ADDENDUM 1

CSP 23-25

GYMNASIUM ADDITIONS/IMPROVEMENTS FOR CANTERBURY & ESCANDON ELEMENTARY SCHOOLS

PROJECT: Edinburg C. I. S. D.
Gymnasium Additions / Improvements for
Canterbury & De Escandon Elementary Schools
CSP #23-25

1 ELECTRICAL POWER PLAN
EP1.11
1/8" = 1'-0"

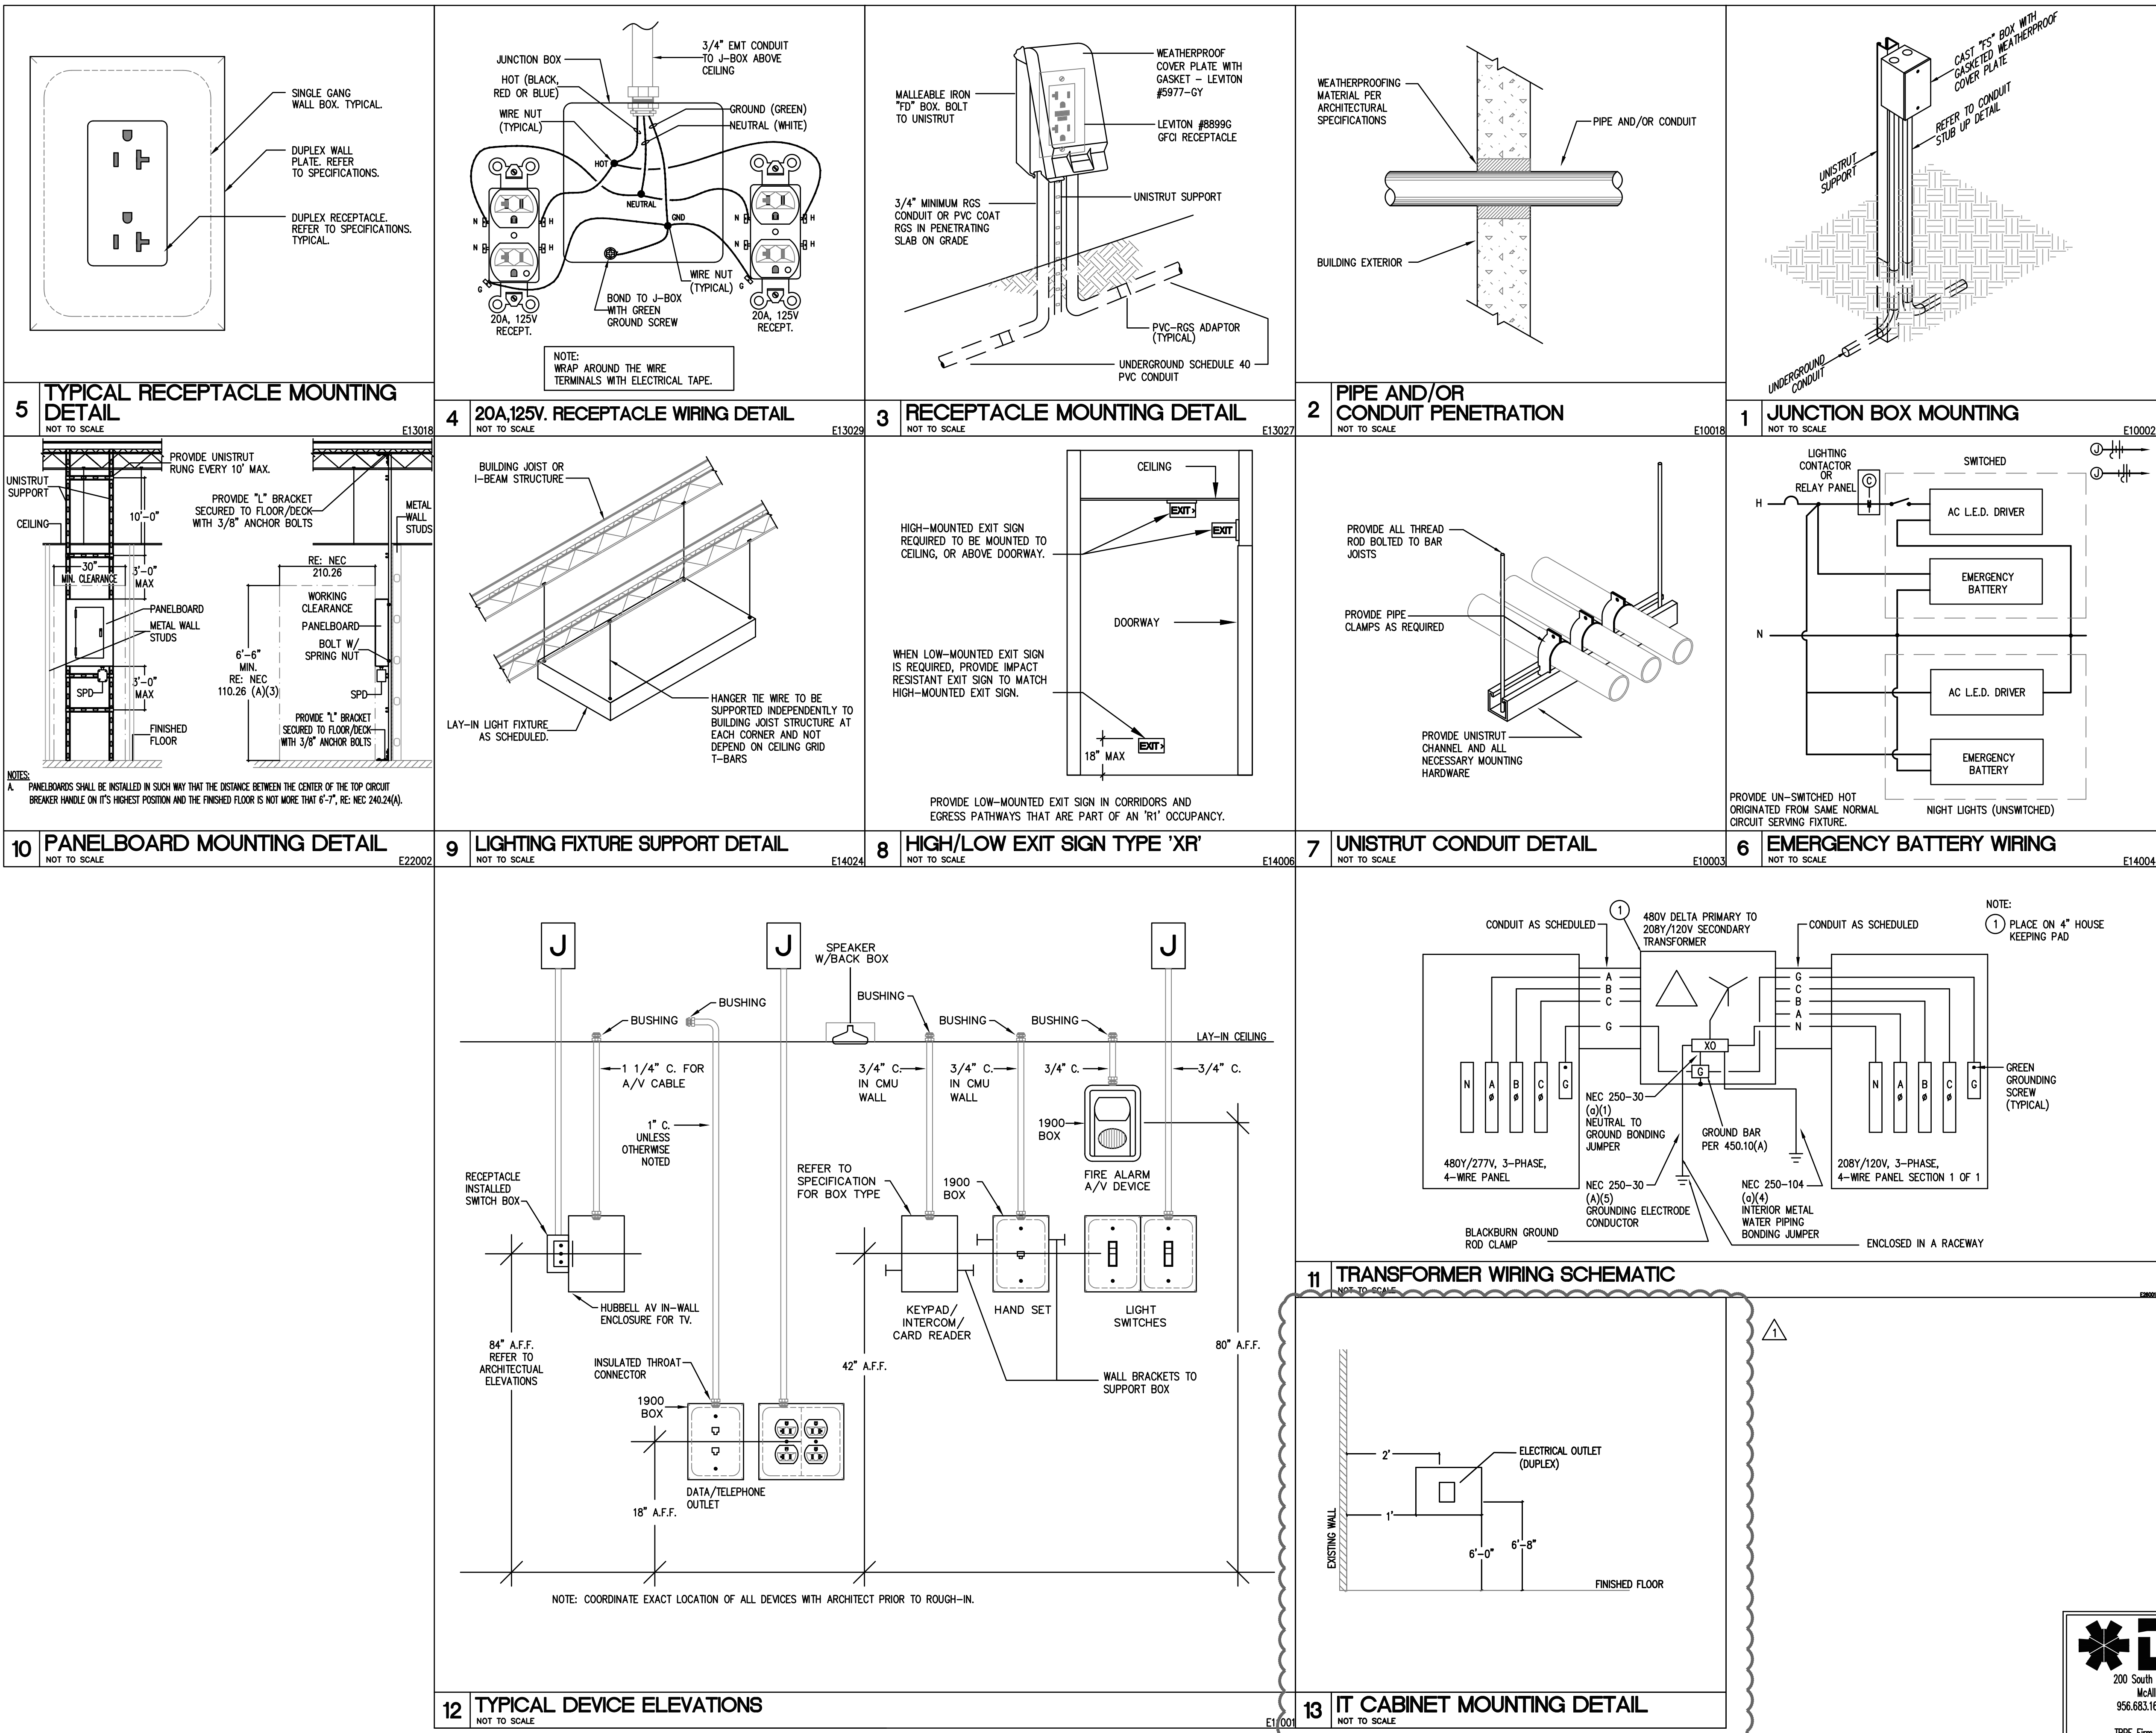
Item 10 Sheet EP1.11 – ELECTRICAL POWER PLAN

- A. Removed RTU disconnects from north end of building.
- B. Added notes.

1 ELECTRICAL LIGHTING AND SPECIAL SYSTEMS PLAN
EL1.11 1/8" = 1'-0"

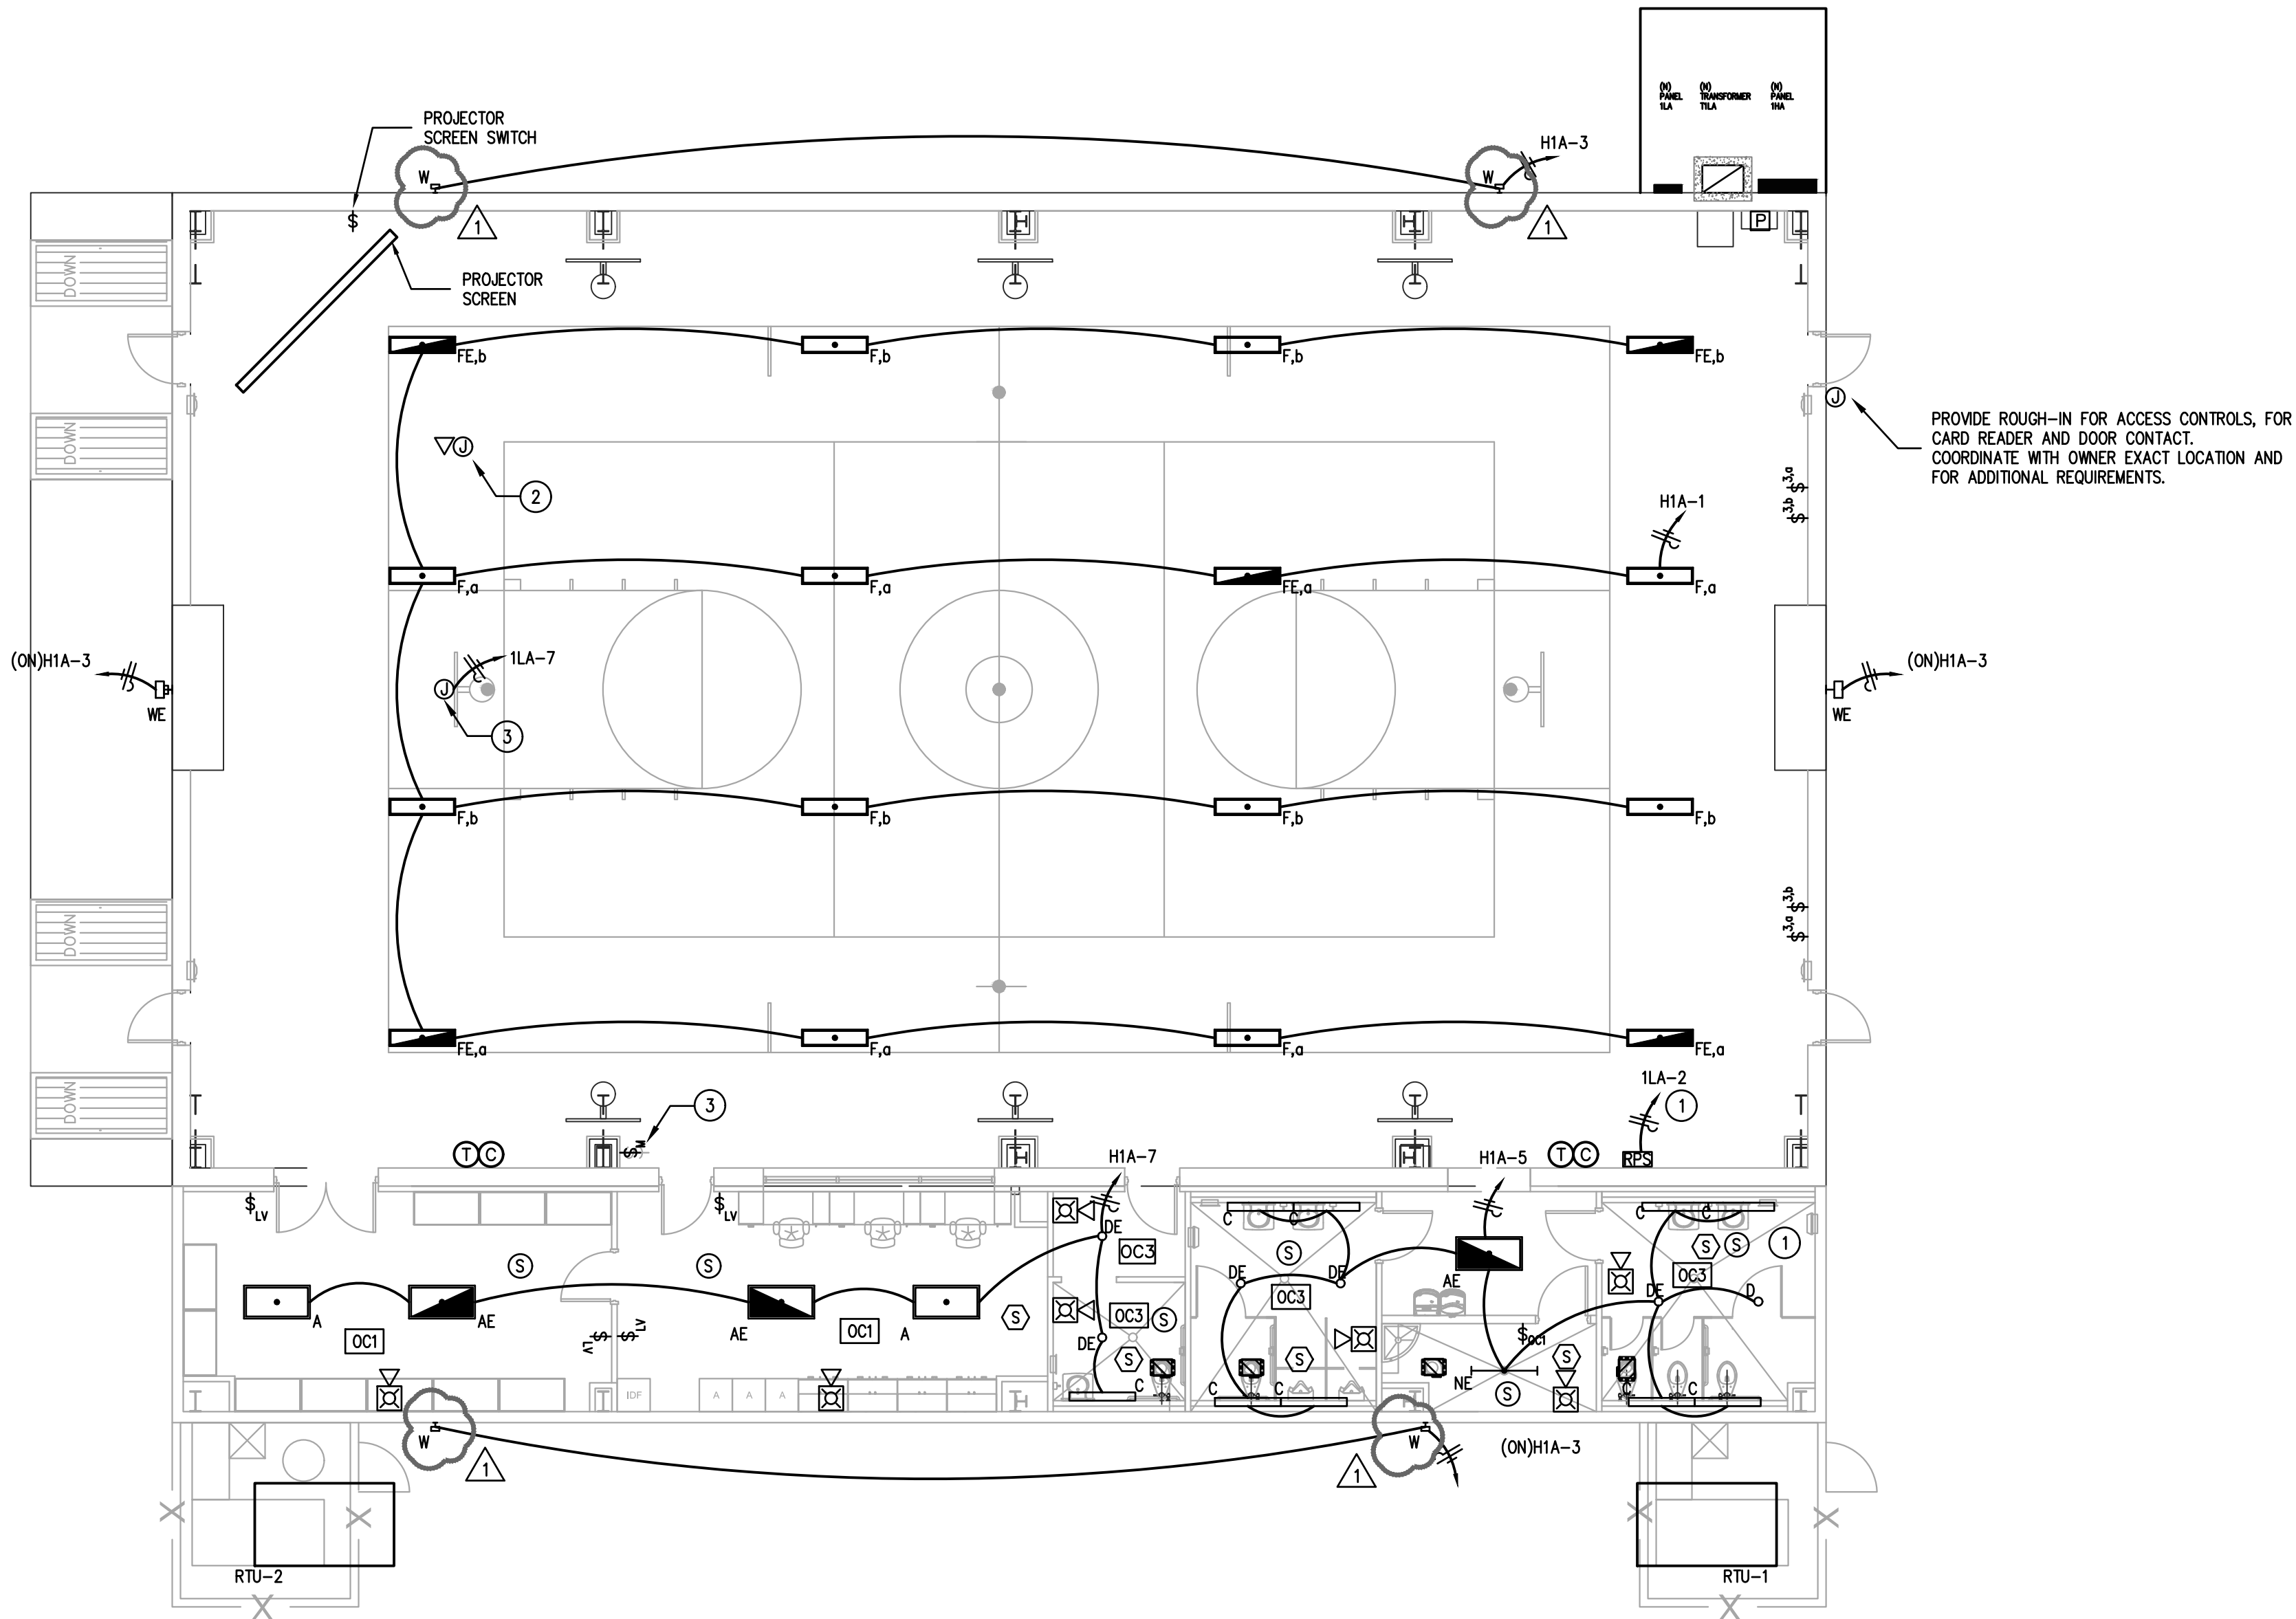
Item 09 Sheet EL1.11 – ELECTRICAL LIGHTING AND SPECIAL SYSTEMS PLAN

1 COMPOSITE LEVEL 1 MECHANICAL PLAN
M1.11 1/8" = 1'-0"

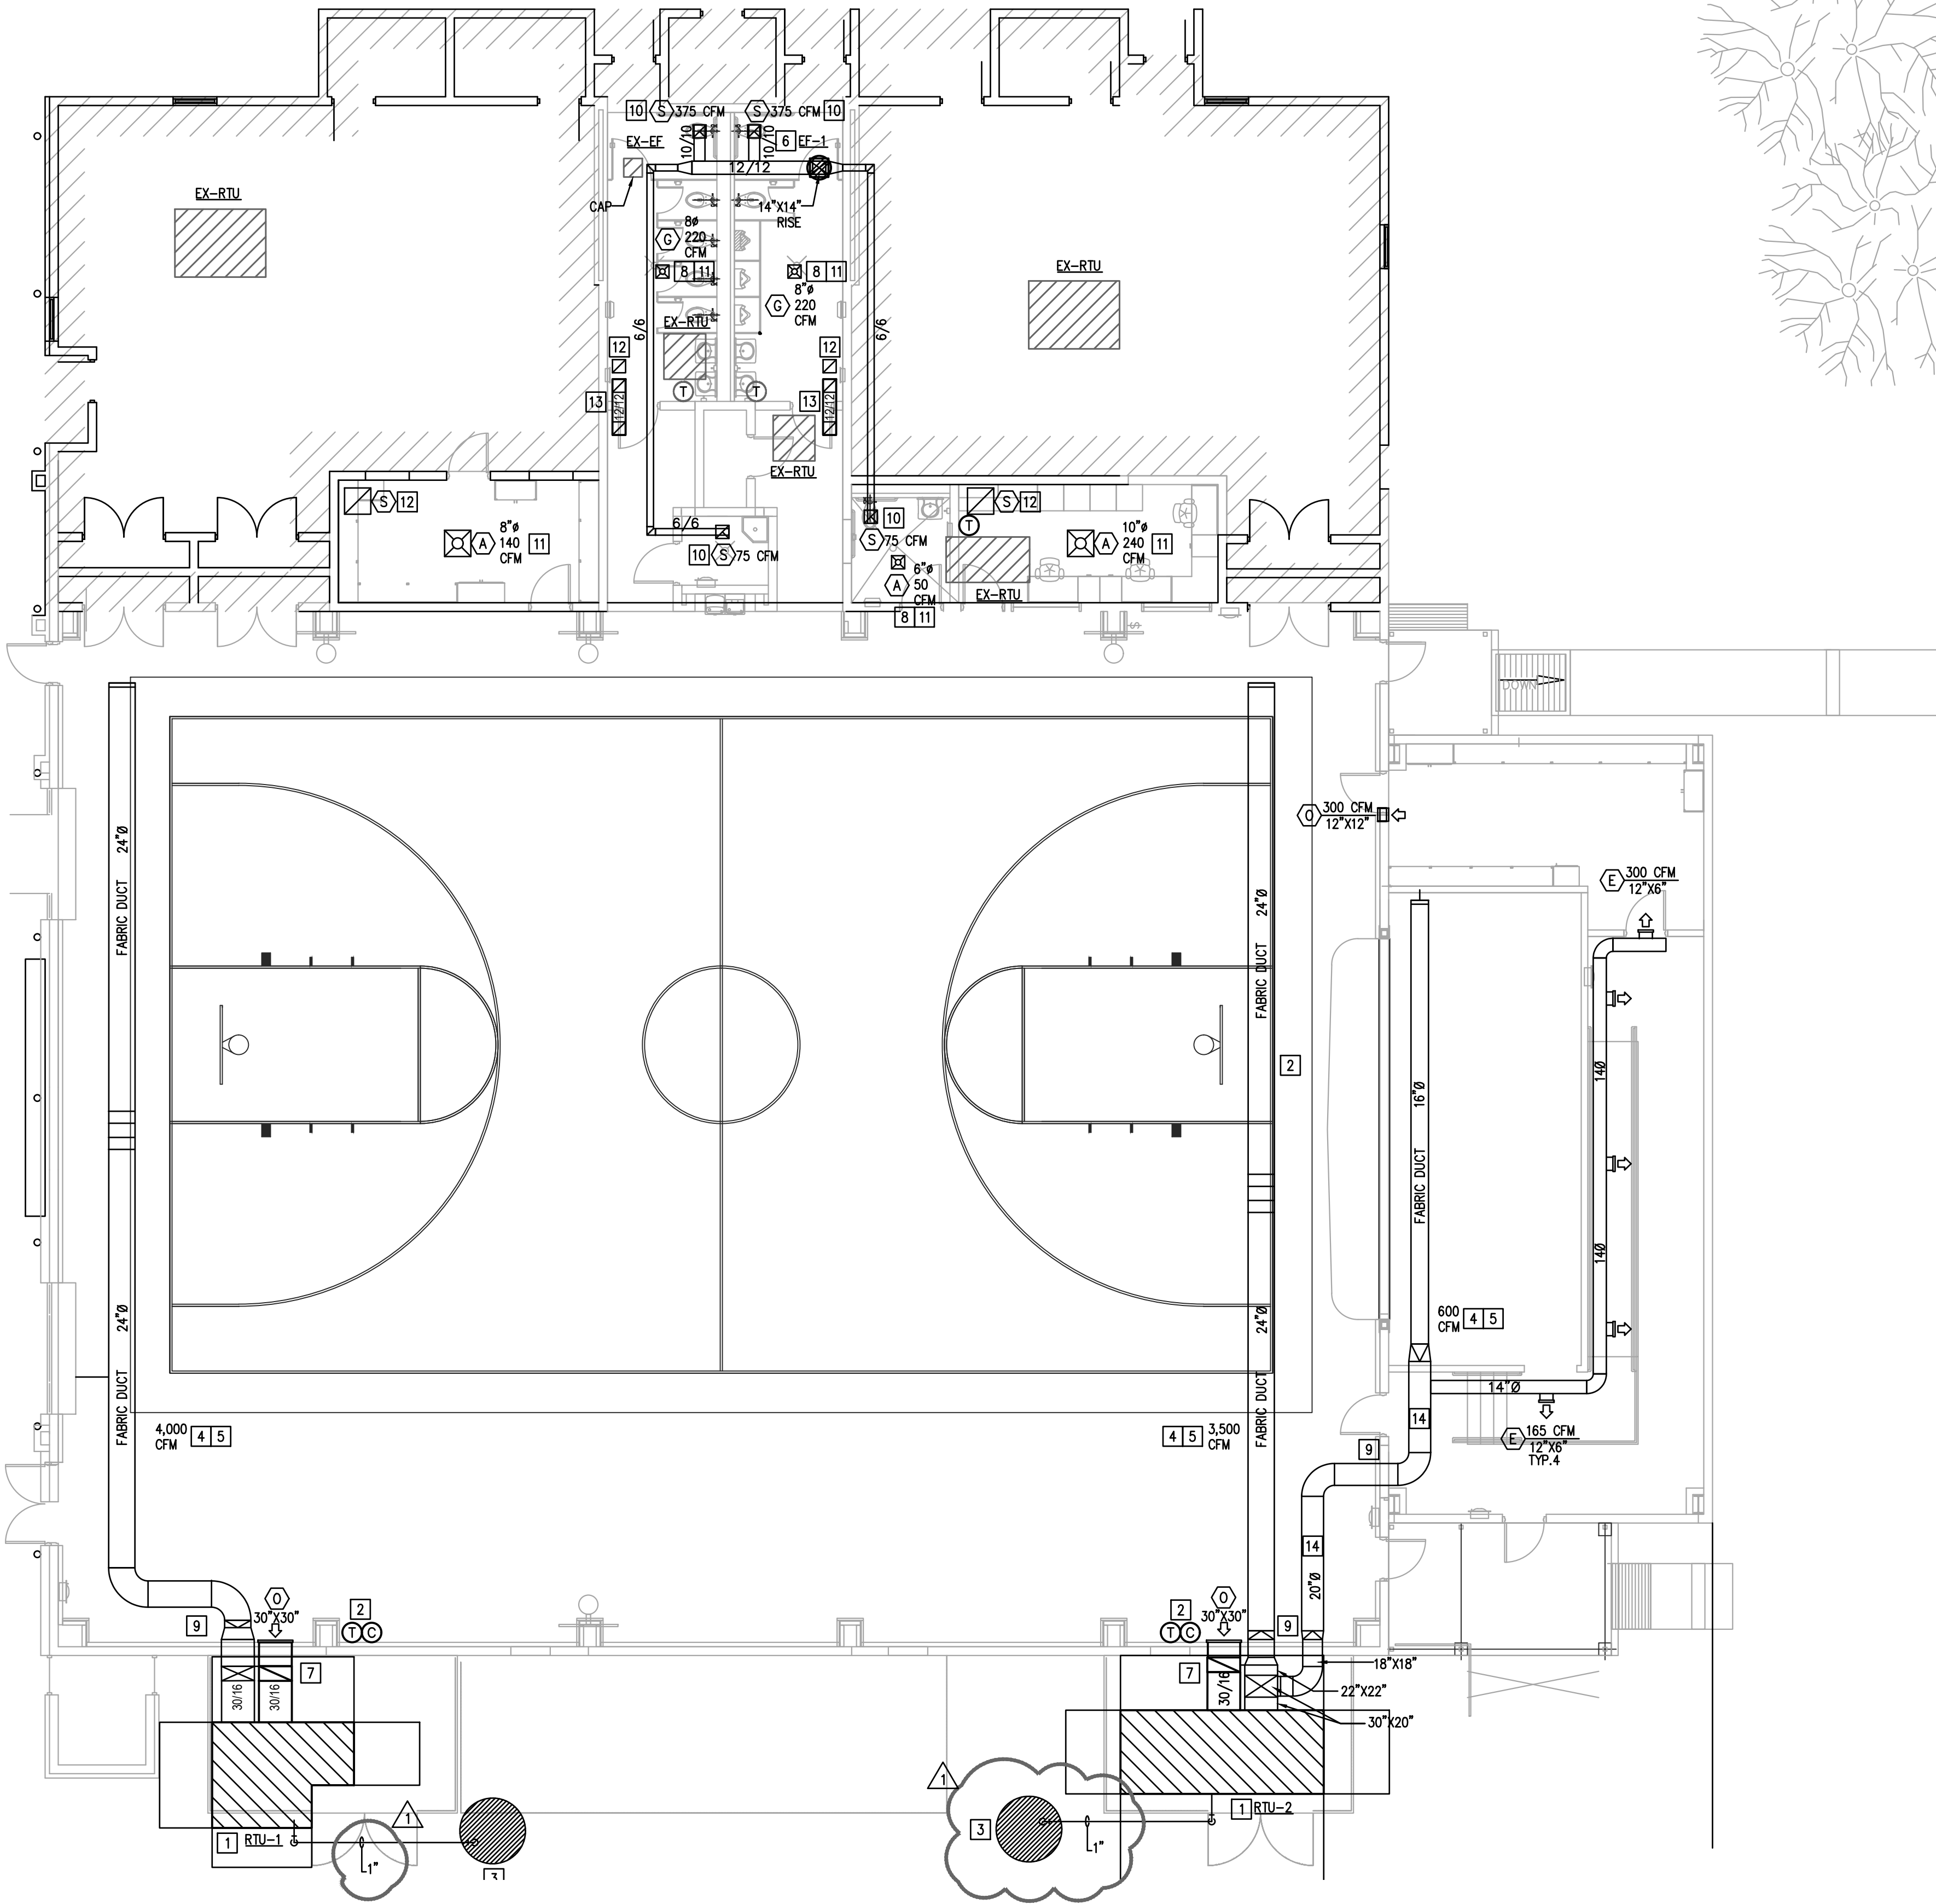
Item 14 Sheet M1.11 – MECHANICAL PLAN

- G. Adjusted the Mechanical Keyed Notes.
